Product Change Notice (PCN)

PCN Number: PCN-0451188R-01

Product(s) Affected: PJ-051A, PJ-051B, PJ-051AH, PJ-051BH

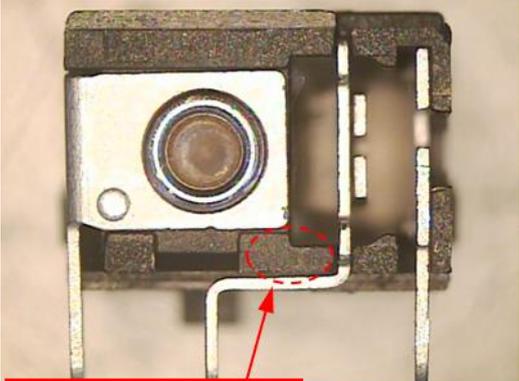
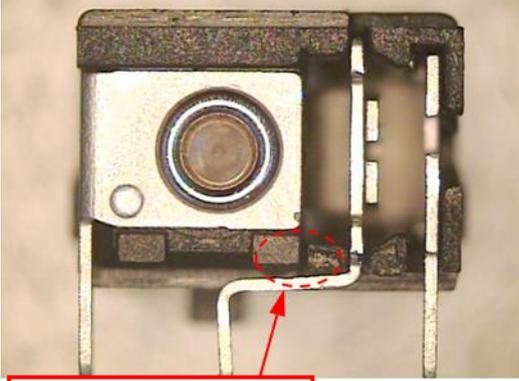
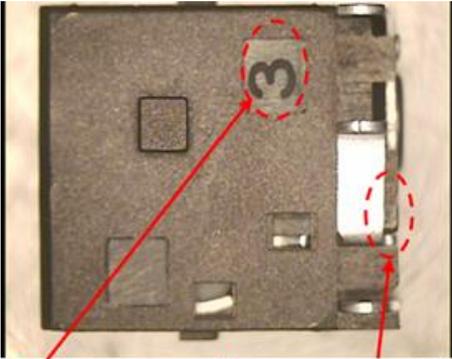
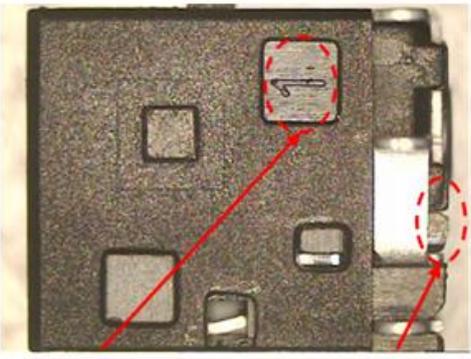
Reason(s) for Change: The existing molds of PJ-051A, PJ-051B, PJ-051AH, and PJ-051BH are unable to maintain efficient production. To ensure the quality and lead-time of production, a re-development of the mold has been processed. We have taken this opportunity to also optimize the product design to enhance the quality. The new mold will optimize the design, enhance the appearance, the electrical structure while function will remain the same (The comparison photos are available below).

New version	Current version
Back	 <p data-bbox="300 831 596 904">Without gap</p>	 <p data-bbox="933 831 1241 904">With gap</p>
Bottom	 <p data-bbox="327 1402 555 1453">Smaller mark</p> <p data-bbox="555 1402 772 1453">Without gap</p>	 <p data-bbox="981 1402 1182 1453">Bigger mark</p> <p data-bbox="1201 1402 1430 1453">With gap</p>
